INDIANA HARBOR BELT RAILROAD COMPANY

BULLETIN ORDER NO. S-17
Effective: 0001 Sunday June 4, 2017

June 2, 2017
General Orders in effect: NONE

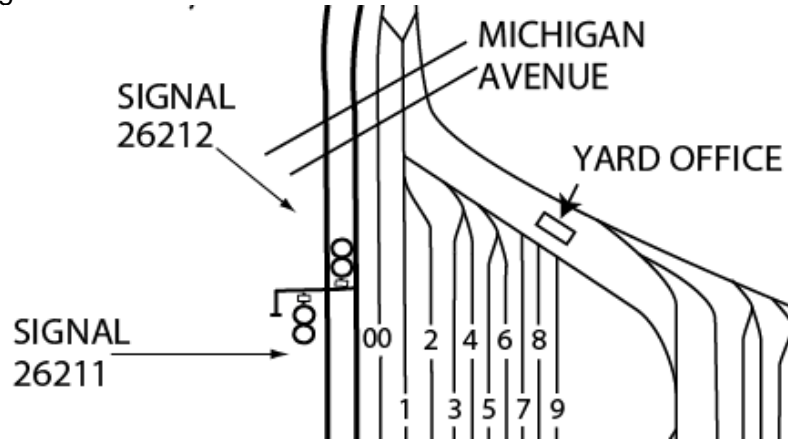
11. IHB Timetable No. 1 Rule 8.2 (a) and 6.27 (a) is added.

<p>8.2 (a)</p>	<p>Switch Point Inspection Test</p>		<p>The card below is used to test employee's compliance with Safety Rule 1800 and GCOR Rule 8.2.</p> <p>Employees observing this card when inspecting switches must not remove it, but contact a supervisor to discuss applicable rules.</p>
<p>6.27 (a)</p>	<p>Obstruction Testing Device</p>		<p>The Obstruction Device pictured below may be used in Operational Testing to determine compliance with GCOR Operating Rule 6.27, Restricted Speed.</p>
